# Access Compliance Report

## Public Rights-of-Way

### (Curb Ramps)

Intersection ID: 19406	Main Street: SOUTH_BV	Cross Street: BOURBON_ST	Location: NW
ADA ID: EA1C08F7D5B2	Ramp Type: Perp	Initial Pass/Fail: Fail	Overall Compliance: No
Severity Score: 22.5			
Codes/Mitigation Info/Possible Solution		Field Measurements/Component Compliance

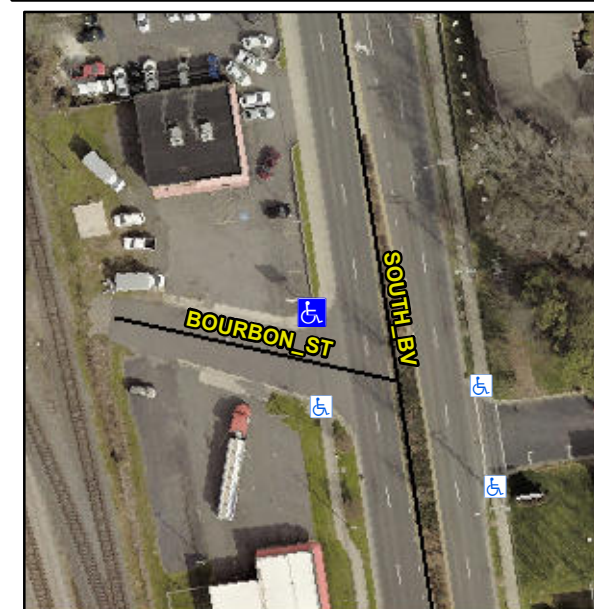
**Not Found, R304.5.1, R304.2.2, R304.5.3**

Compliance	Description	Data	Compliance	Description	Data
N/A	Ramp Length (in)	72.0	No	Ramp Slope (%)	8.8
No	Ramp Width (in)	47.0	No	Ramp XSlope (%)	4.2
N/A	Flare Type LT	N/A	N/A	Flare Type RT	N/A
N/A	Flare Slope LT (%)	N/A	N/A	Flare Slope RT (%)	N/A
N/A	Flare Traversable LT?	N/A	N/A	Flare Traversable RT?	N/A
N/A	Landing Length (in)	N/A	N/A	DWS Provided?	N/A
N/A	Landing Width (in)	N/A	N/A	DWS Contrast?	N/A
N/A	Landing Slope (%)	N/A	N/A	DWS Length (in)	N/A
N/A	Landing X Slope (%)	N/A	N/A	DWS Full Width?	N/A
N/A	Landing Curb? (Y/N)	N/A	N/A	DWS Offset (in)	N/A
N/A	Shared Landing?	N/A			
N/A	Gutter Ponding?	N/A	N/A	Gutter Slope (%)	N/A
N/A	Gutter Lip Ht (in)	N/A	N/A	Gutter X Slope (%)	N/A
N/A	Painted X Walk1?	No	N/A	Painted X Walk2?	N/A
	X Walk 1 Direction	To S		X Walk 2 Direction	N/A
N/A	X Walk 1 Width (in)	N/A	N/A	X Walk 2 Width (in)	N/A
	X Walk 1 Slope (%)	1.9		X Walk 2 Slope (%)	N/A
	X Walk 1 X Slope (%)	5.3		X Walk 2 X Slope (%)	N/A

**Remove & Replace Entire Ramp.**
